Subject: McGuire Nuclear Station, Docket Nos. 50-369 and 50-370
Proposed Technical Specification Amendment to Increase the
Allowable Temperature of the McGuire Standby Nuclear Service
Water Pond

Technical Discussion, No Significant Hazards and Environmental Analysis

SWSWP INTAKE TEMPERATURE TREND

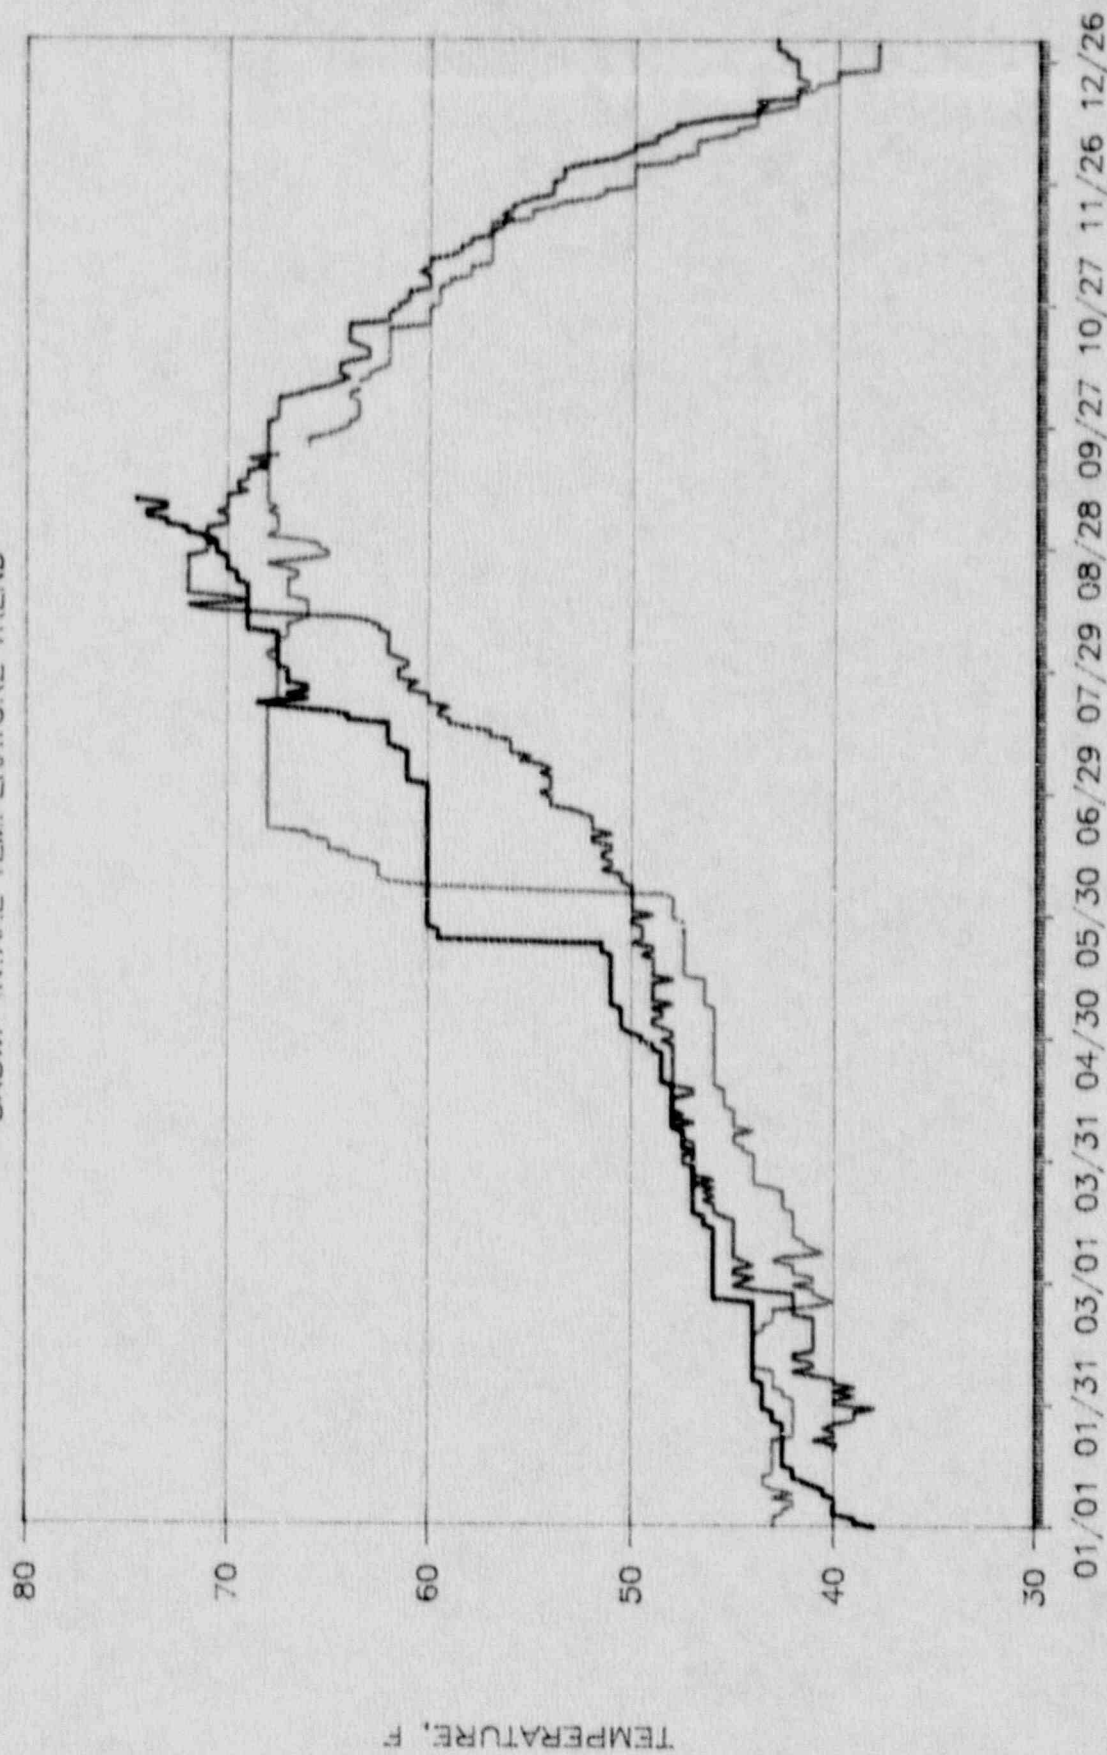
The proposed amendment to increase the current SNSWP temperature of 78 degree-F to less than or equal to 82 degrees-F is requested for the following reasons. In August 1988, the monitored temperature of the SNSWP at elevation 700 feet reached as high as 74 degrees-F (see attached SNSWP Temperature Trend figure). In 1989, multi-point depth temperature surveys of the SNSWP were performed. The following data was obtained in September 1989, during the hottest period of the year:

The increased SNSWP temperature has been attributed to recent higher ambient temperatures and less seasonal rainfall during the high temperature months of July, August, and September as experienced over the past few years.

Revise TS 3/4.7.5 Standby Nuclear Service Water Pond, Section 3.7.5.b, to require an average water temperature of less than or equal to 82 degrees-F (instead of 78 degrees-F) at elevation 718 feet (instead of elevation 700 feet).
